EMERGENCY ALERT SERVICE BULLETIN

TITLE: Tail rotor drive - Limitations on the center shaft assembly

Model:	EC130
Version:	B4, T2

[EASB EC130-65-00-0001](#)

Figure 1

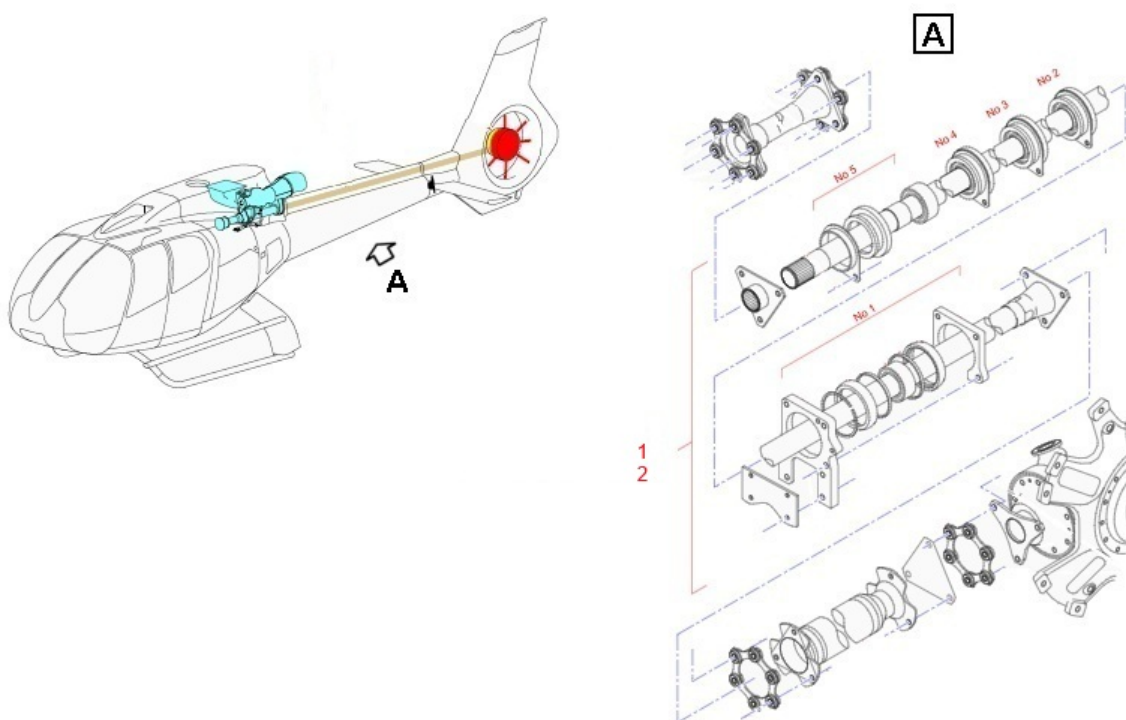
- 4.1. Remove the center shaft assembly (1) ([Figure 1](#)). Refer to [AMM 65-11-00.4-3](#).
- 4.2. Install a serviceable center shaft assembly (2). Refer to [AMM 65-11-00.4-4](#).

- 4.3. Contact Airbus Helicopters to get instructions to send back the center shaft assembly (1) to Airbus Helicopters.

If a serviceable central shaft assembly is installed, this EASB is applicable again when the center shaft assembly reaches 6100 FH for EC130 B4 and 5600 FH for EC130 T2.
